Lee's Summit Missouri
Development Services
ATTN: Joe Frogge
Carhartt – Lee's Summit
1744 NW Chipman Rd., Lee's Summit, MO 64081
Permit Number: PRCOM20252521

Please see below for responses to permit comments.

STRUCTURAL CALCULATIONS
UNIT ANALYSIS

1 CONSTRUCTION PLAN / FINISH PLAN

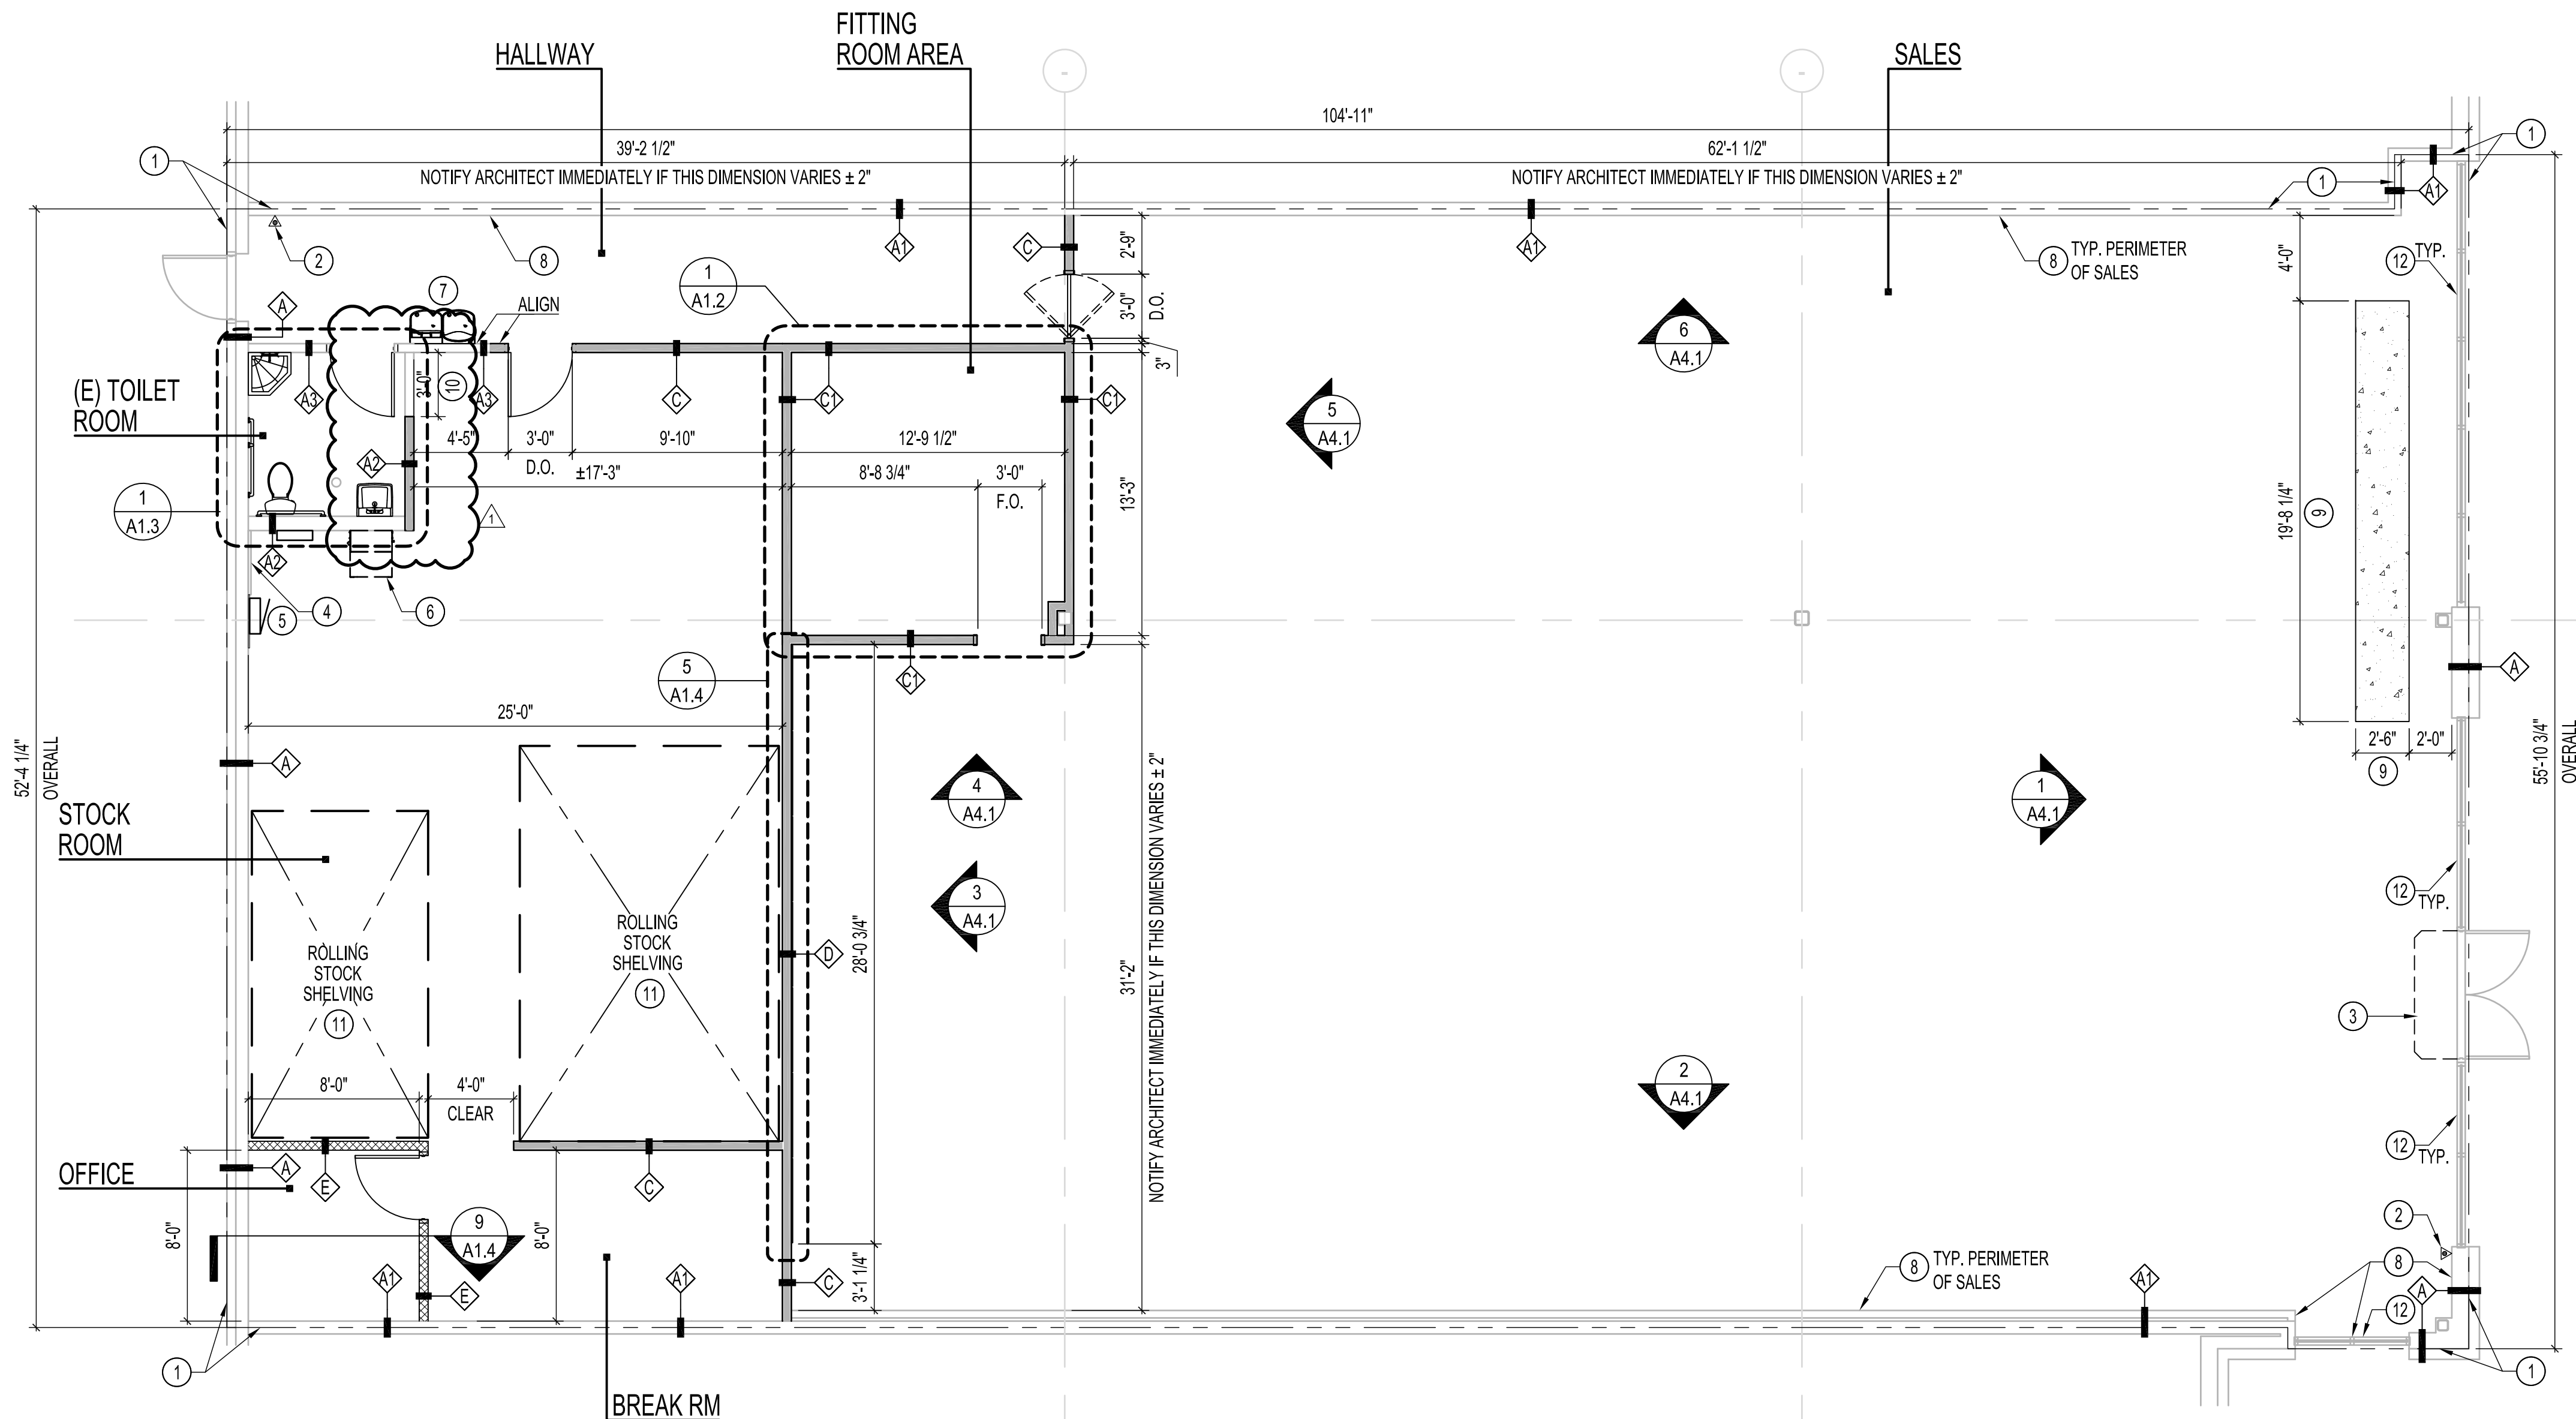
| Comment ID | Review Comment | Response |
|------------|---|---|
| 1 | 2018 IBC 505.3.3 Guards. Equipment platforms shall have guards where required by Section 1013.2. Action required: Provide guards at equipment platform. | Sheet A1.1 has been updated to provide guard wall extending 42" above platform. |
